104 AVENUE CORRIDOR PLAN

Public Workshop #2 Feedback Summary

CONCEPTUAL SCENARIO 1:

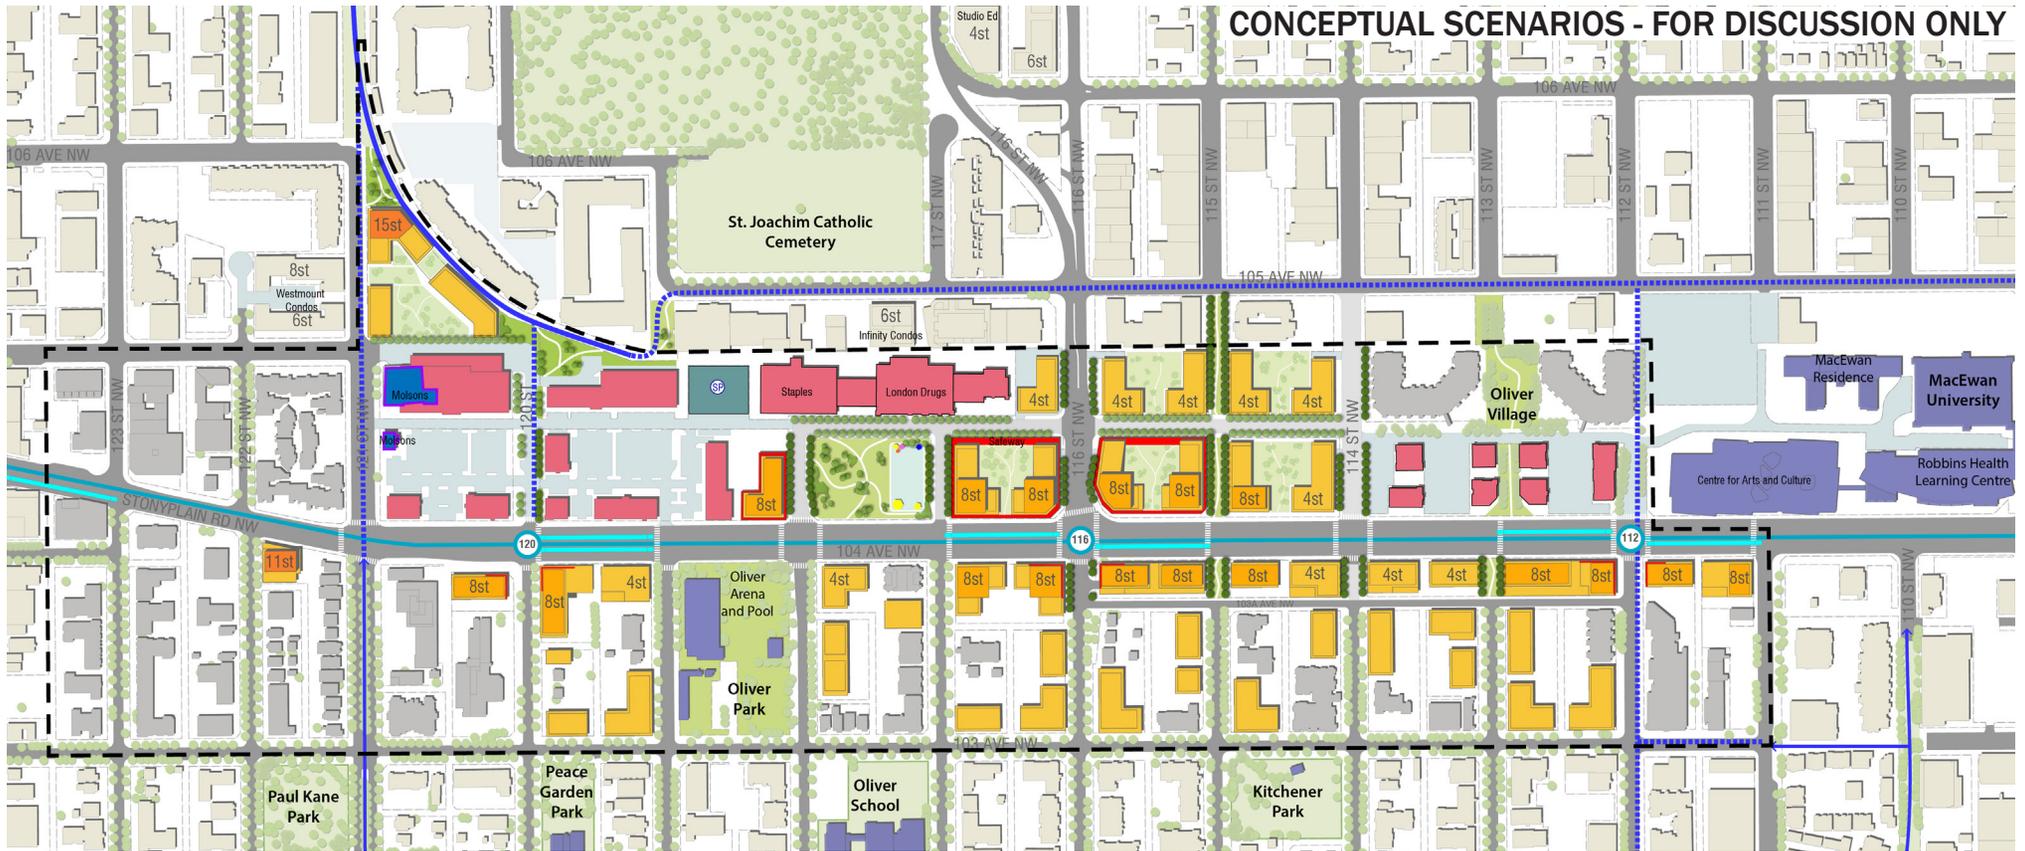
- North-south connections for pedestrians and cyclists
- Redevelopment of Long Street site
- Central gathering place
- Increased parks/green space
- New east-west connection

- New and extended cycling routes
- Vertical mixed-use
- Moving Safeway to the street
- Moderate height and density
- Connection of 114 Street

- Pedestrian focus
- Greatest total surface redevelopment of the scenarios
- The focus of redevelopment at 116th Street
- Retail located close to the street
- Nice combination of retail and residential
- Retail focused around LRT stops
- Maintaining Oliver Village
- Retention of many existing buildings
- This scenario would be appropriate if current growth projections are overestimated
- Very pragmatic plan

- Still too much surface parking
- Not enough density
- Single large open space
- Retaining Oliver Village and the Molson development

- Not enough pedestrian amenities
- Connectivity to and through 104 Avenue is still lacking
- Retaining 103A Avenue
- Doesn't go far enough to turn 104 Avenue into an urban corridor
- Retail is fragmented
- Location of central gathering space
- Nothing unique about the concept

- Should be more bike boulevards
- Not enough vertical mixed use
- Buildings are too tall
- Potential for shadowing on south side of 104 Avenue
- Not enough green space
- Development is inward facing
- Not enough retail on south side of 104 Avenue
- Too much commercial development
- Not enough redevelopment
- Suburban/small city feel
- Concept is still vehicle-reliant

CONCEPTUAL SCENARIO 2: Re-Urbanizing 104 Avenue as a High Density Corridor

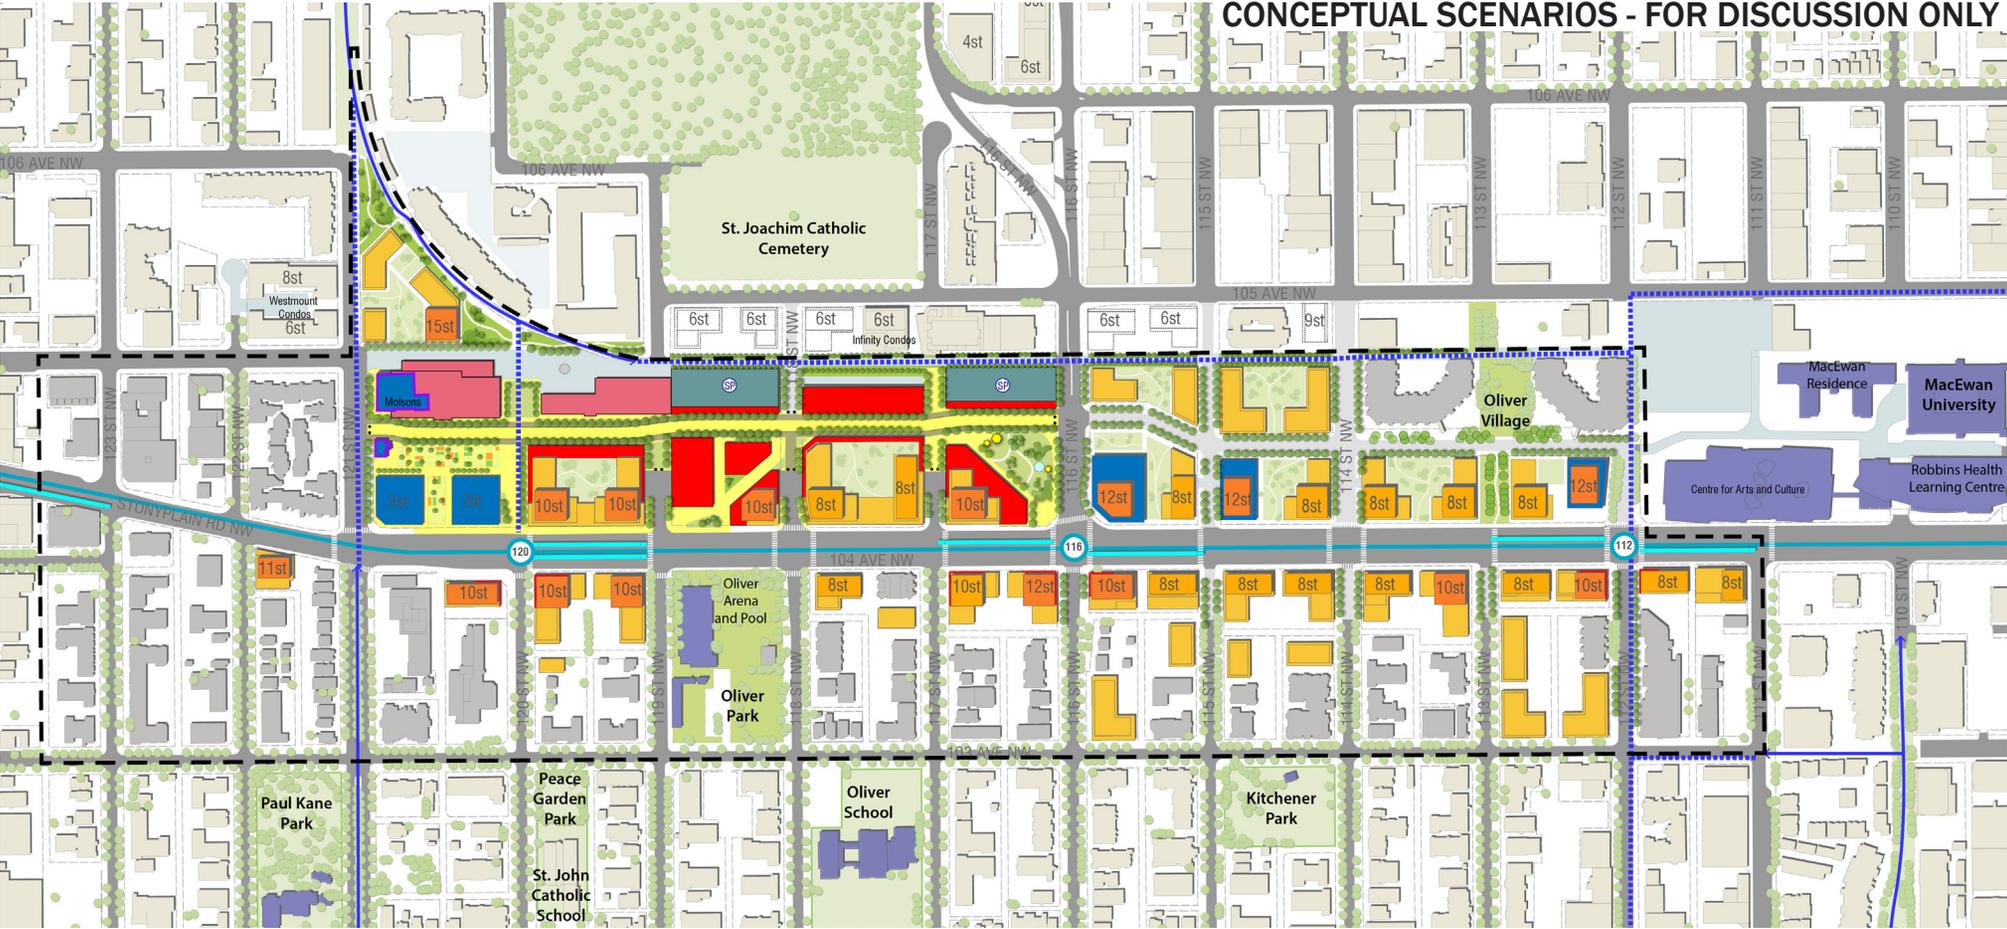
- Increased density and height
- Density and height clustered around LRT stops
- East-west greenway
- North-south connectivity
- Smaller open spaces distributed throughout
- Vertical mixed use
- Minimizing surface parking
- Additional cycling routes, particularly the bike path through the greenway from Molson to MacEwan

- Connection to Ribbon of Steel trail
- Urban form large format retail
- Pedestrian focus
- Removal of 103A Avenue

- Urban plaza
- Redevelopment of Long Street site
- Reduced setbacks of buildings in Oliver
- Urban nature of development
- Mix of large and small format commercial
- Residential areas on both sides of 104 Avenue
- Street-oriented development on 104 Avenue
- This scenario positions the city well for growth
- Connection of 114 Street

- Height and density are too high
- “Suburban” form large format retail

- 104 Avenue needs to be more pedestrian friendly
- Molson site not fully redeveloped
- Not enough parking for such a high density area
- There is no need to connect both 114 and 115 Streets as streets

- Lack of offices misses opportunity to take advantage of LRT ridership
- Lack of mixed use on south side of 104 Avenue
- Oliver Village retail should stay
- Inward-focused buildings
- There should be a mix of housing types
- Bike path should be on a main street
- Greenway will create a clash between pedestrians and cyclists
- Parks should be on local streets
- Traffic will increase with this concept
- Extends the busy downtown feel
- Concern about impacts of tall buildings: shadows, wind tunnels, reduced view corridors

Approved Section

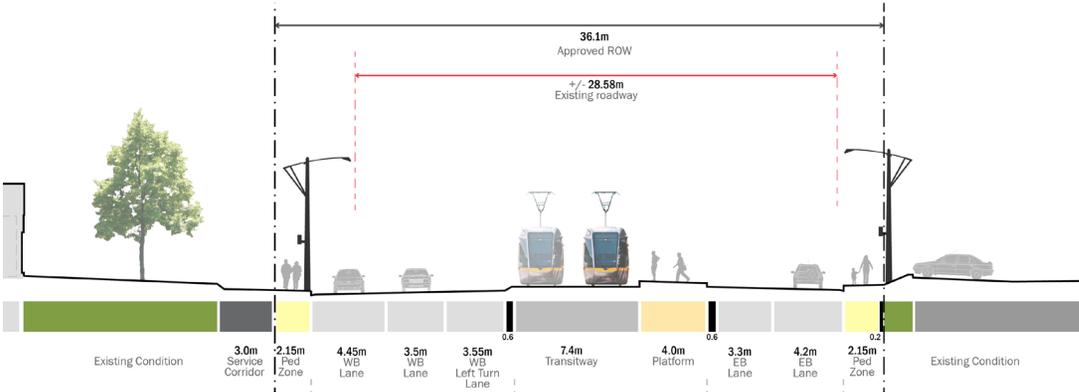
- Boulevard that allows for the use of green technology such as bioswales, rain gardens
- Approved section is acceptable to keep costs down and have LRT completed as soon as possible
- Alternative Section B is the best, but perhaps could be implemented only on the north or south side
- Eliminating the extra width in the curb lane is good because it would be unsafe for cyclists anyway
- Alternative Section A is good, especially if combined with the pedestrian-focused street from Scenario 3
- Traffic lanes could be even narrower
- Service corridor could be used for street furniture, etc

- The approved section is unacceptable
- No boulevard for pedestrian safety in the approved section
- Wide traffic lanes in the approved section

- Approved Section does not improve the liveability of the 104 Avenue corridor
- Hard to see how the bus system aligns with these
- Concern about how reduced traffic lane widths affect safety
- Concern that having to acquire land will slow down improvements
- Need to look at design choices to reduce vehicle speeds
- The LRT will be a major barrier between the communities to the north and south of 104 Avenue and the plans don't offer a pedestrian friendly means of crossing 104 Avenue
- 104 Avenue should be reduced to three lanes with one where the direction of traffic can be reversed depending on time of day

Alternative Section A

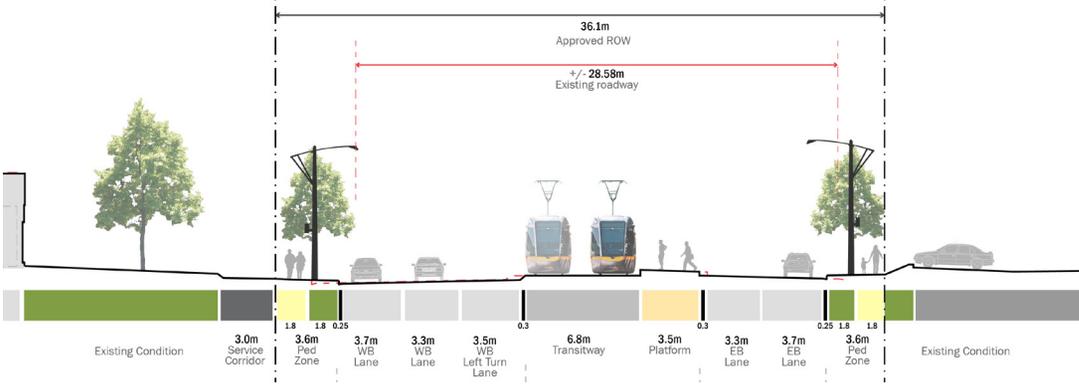
- Narrower traffic lanes
- Alternative Section A is the best – more space without having to purchase more land
- Benches and other pedestrian amenities

Alternative Section B

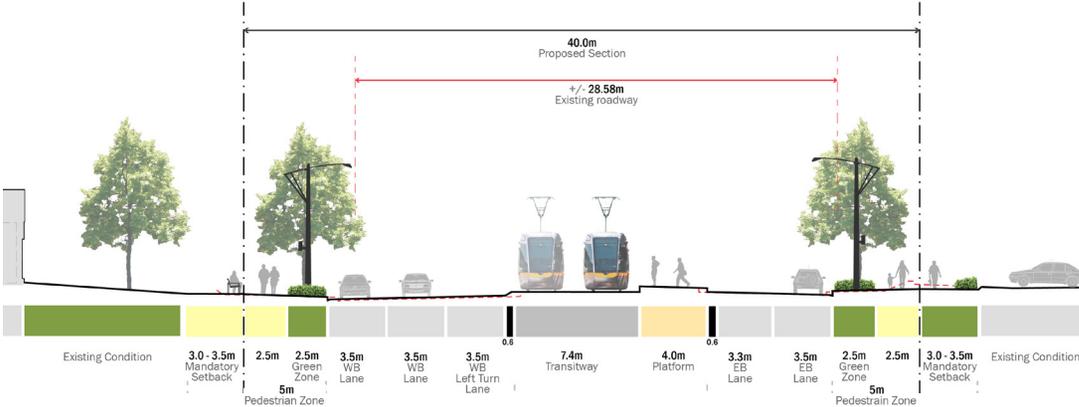
- Alternative Section B is the best
- Wide boulevards for safe separation, snow storage, landscaping
- Mandatory setbacks for seating and patios
- Trees
- Wide sidewalks
